RHODE ISLAND COASTAL RESOURCES MANAGEMENT COUNCIL  
REPORT OF FINDINGS -- PRELIMINARY DETERMINATION

**NAME:** Eileen Biancuzzo      **CRMC FILE NO.** D2019-03-087  
**LOCATION/POLE:** Matunuck Beach Road  
**CITY/TOWN:** South Kingstown      **PLAT:** 92-2      **LOT:** 56

**PROPOSAL:** To create a 20-unit subdivision (five 4-unit townhouses) serviced by public water and on-site septic systems.

**PLAN(S) REVIEWED:** "Site Layout Plan, Matunuck Beach Road Condos, AP 92-2, Lot 56, South Kingstown..." as last revised 3/21/19 by DiPrete Engineering.

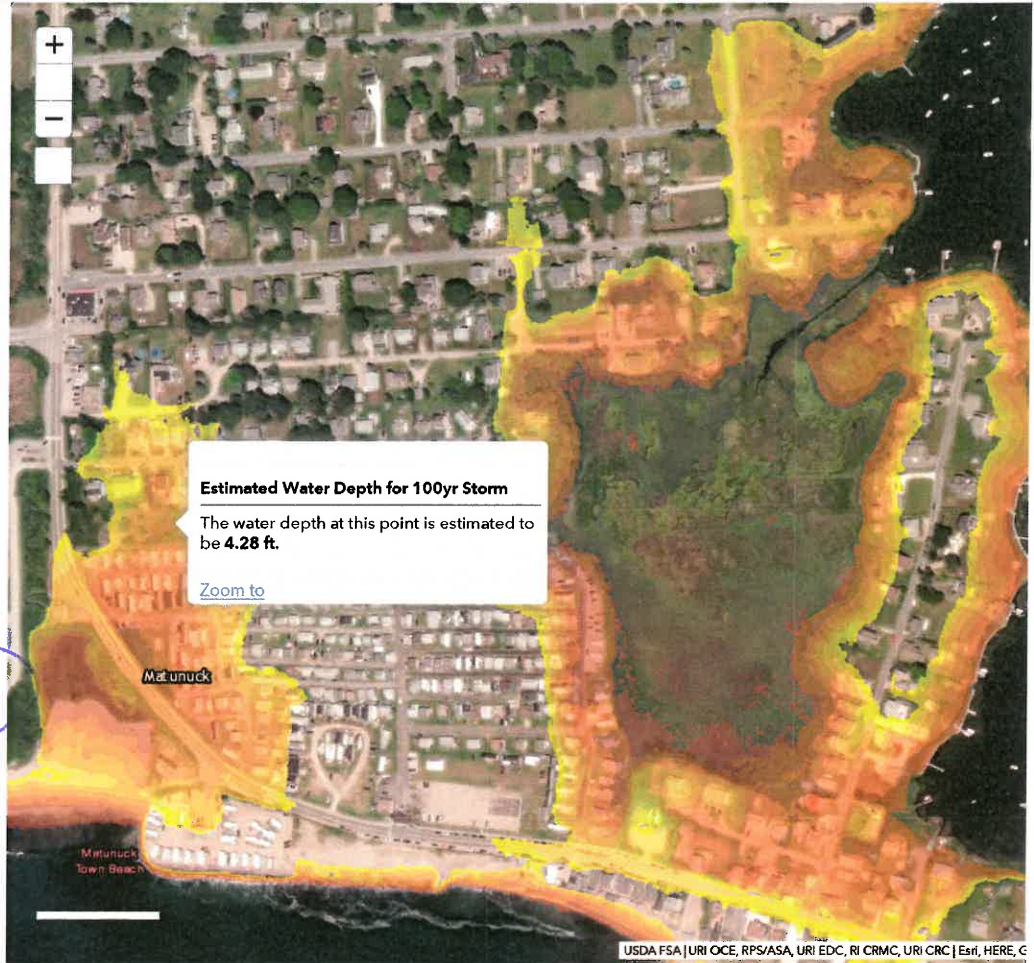
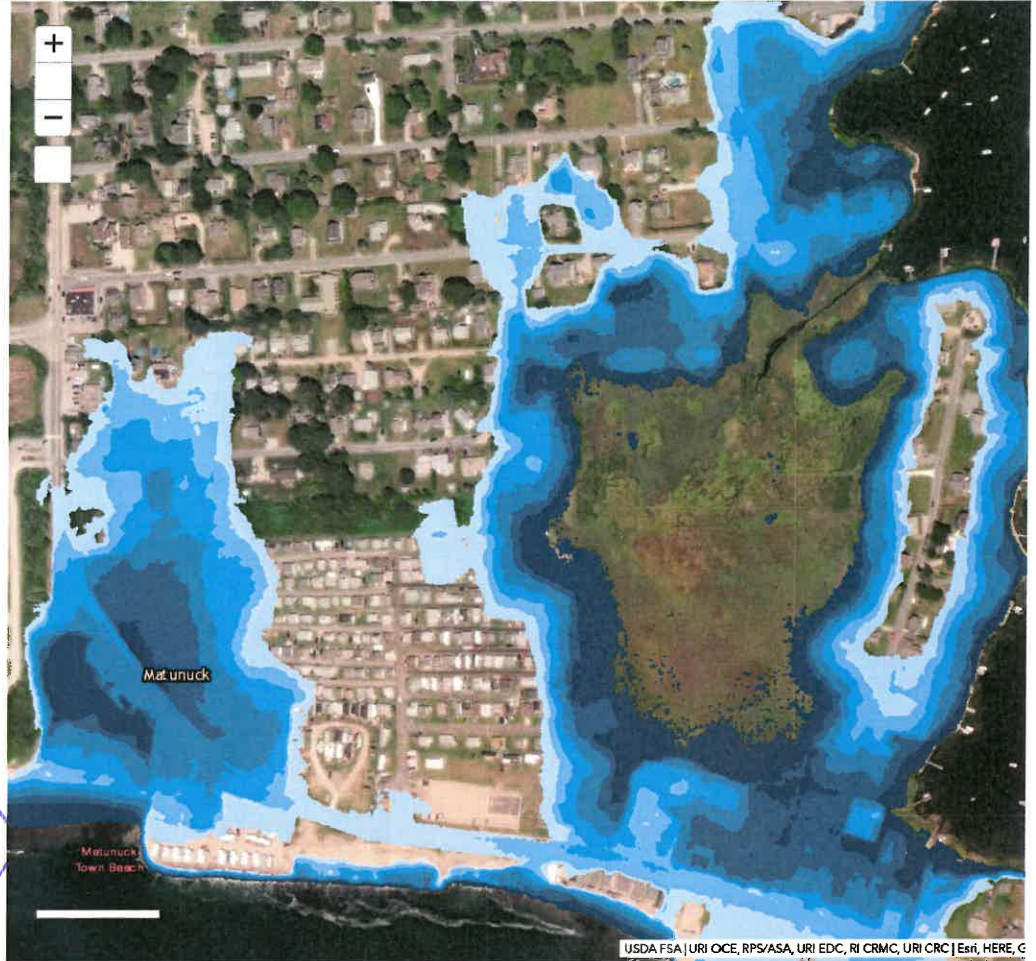
- 11) Lastly, the applicant shall address Section 1.3.1(A) as well as Section 1.1.10 of the RICRMP and review the attached Stormtools mapping projections for this site under various future sea level rise scenarios. Additionally, the SLAMM maps available on CRMC's website shall be utilized in formation of this project design, as the adjacent coastal wetland is one of the largest along this waterbody.
- 12) The lot is able to support residential development at this time, however reconfiguration in accordance with the above requirements is necessary to be consistent with CRMC programmatic concerns. Any standards not met shall be accompanied by a written variance request (ref. Sec.1.1.7) at the time of future application.
